Proposal #11: 2120-18-70, WISC 2025100
Hales Corners - Milwaukee
USH 45 to 45th Street
STH 24
Milwaukee County

This is Addendum No. 04, which provides for the following:

ADDENDUM NO. 04
2120-18-70/2160-07-73
December 6, 2024

MODIFIED TYPE C BARRIER
THRIE-BEAM CONNECTOR PLATE

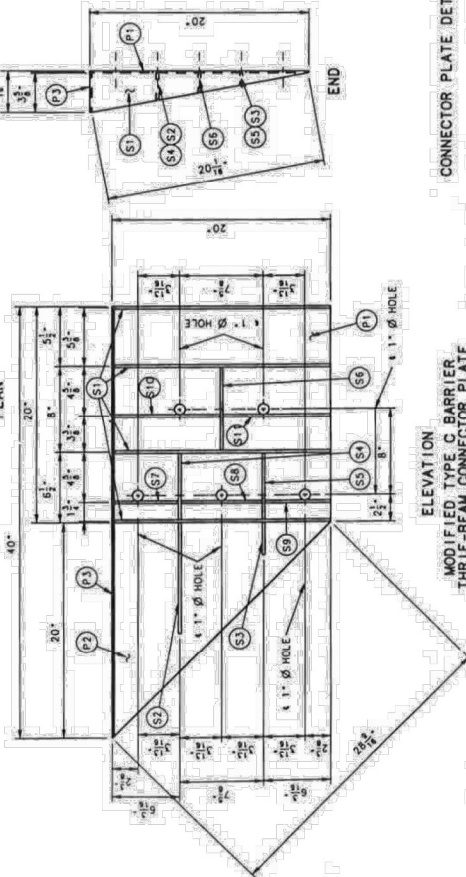
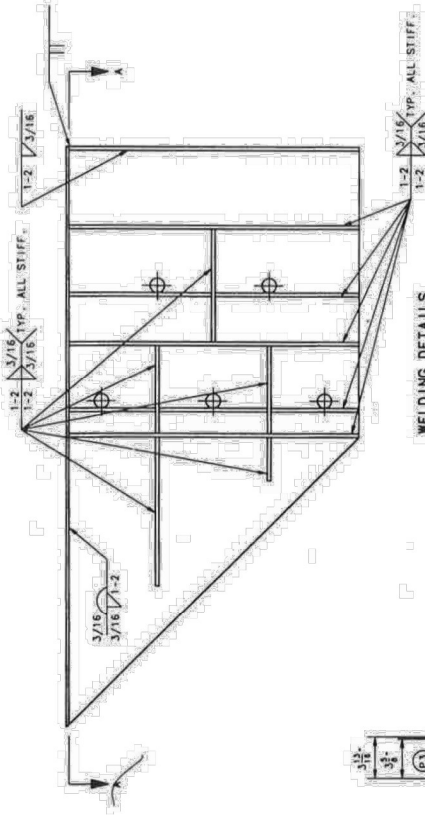
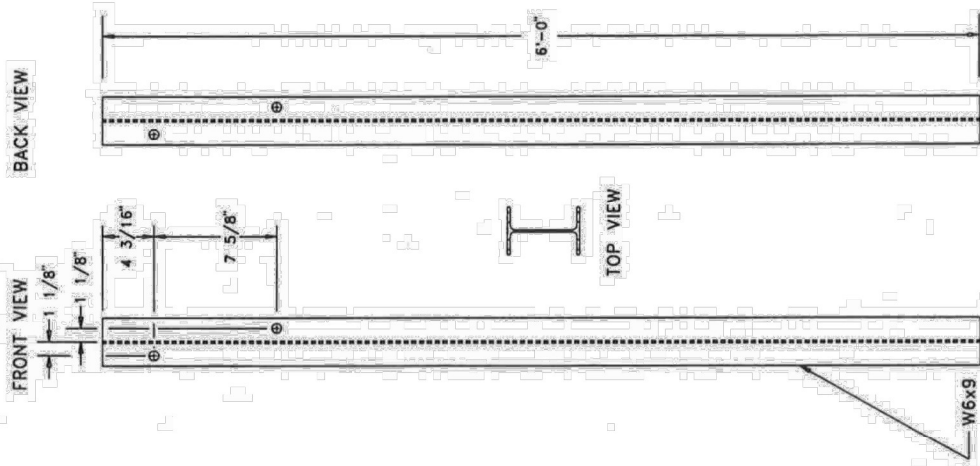
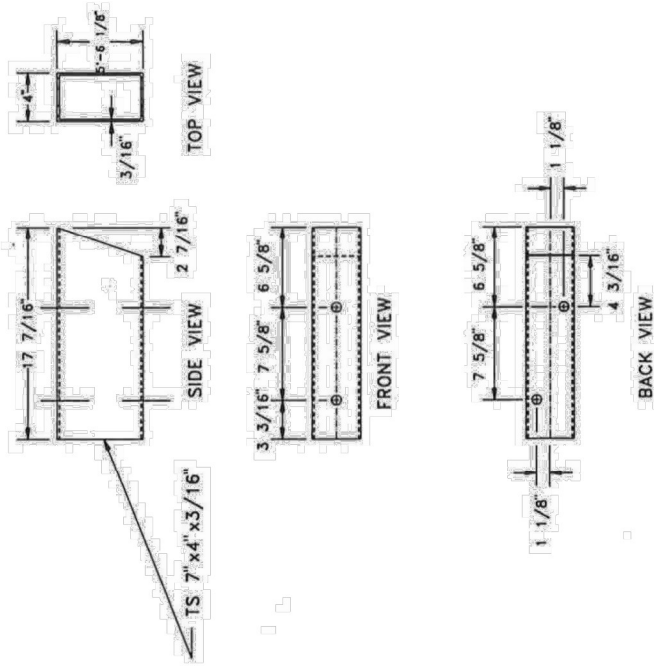
Added Plan Sheets 2120-18-70	
Plan Sheet	Plan Sheet Title (brief description of changes to sheet)
21A-21D	Construction details for the double sided thrie beam transition.

No. 04
3-70
Sheet 169
6, 2024

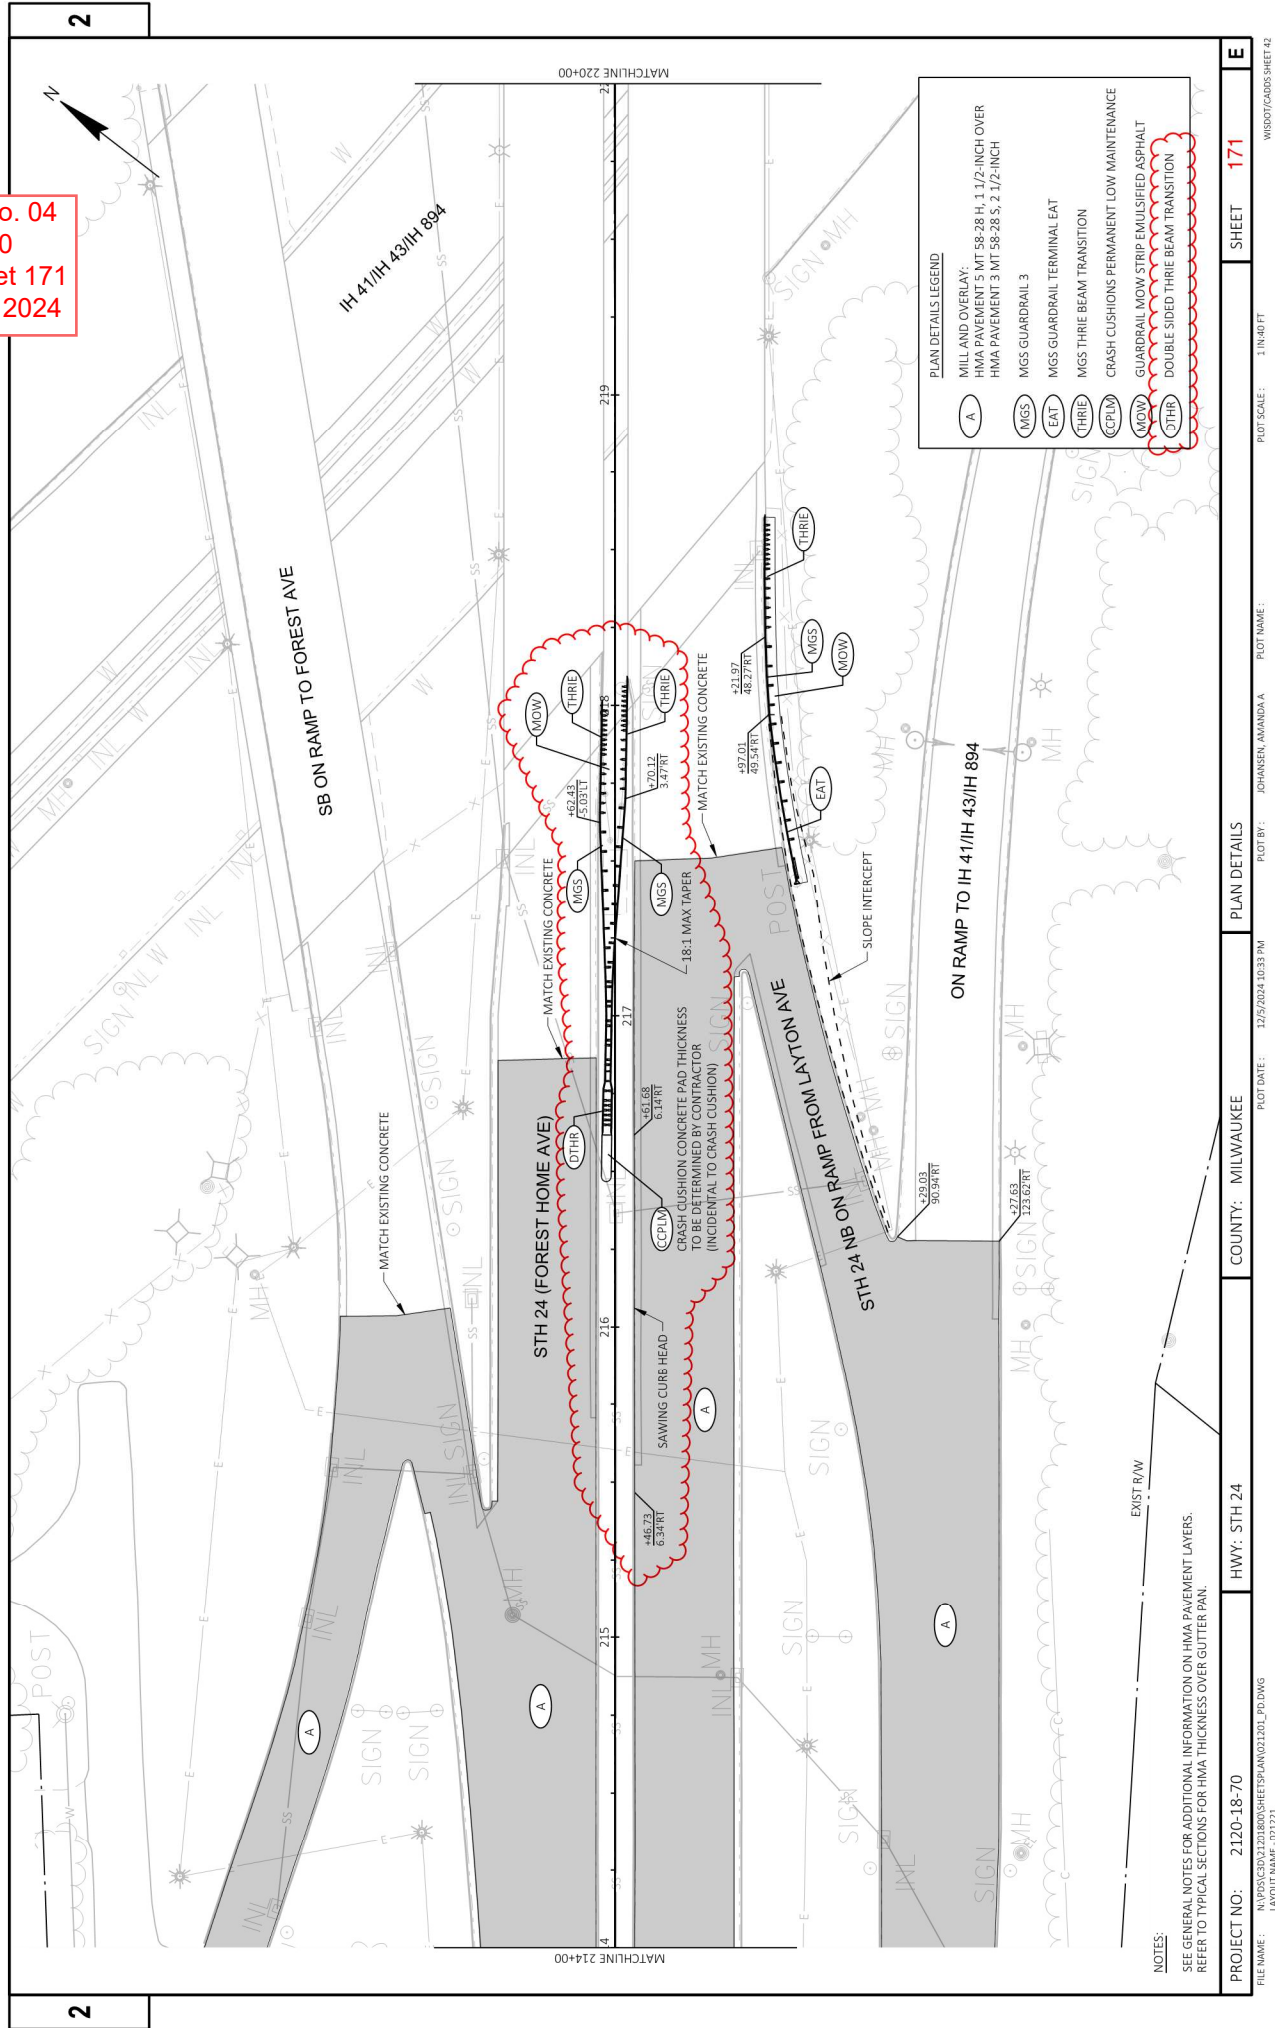
Revised Plan Sheets 2120-18-70	
Plan Sheet	Plan Sheet Title (brief description of changes to sheet)
169-174	Plan Details – updated beam guard to include thrie beam transitions connecting to the crash cushions.
584	Miscellaneous Quantities – Revised “Beam Guard” table.
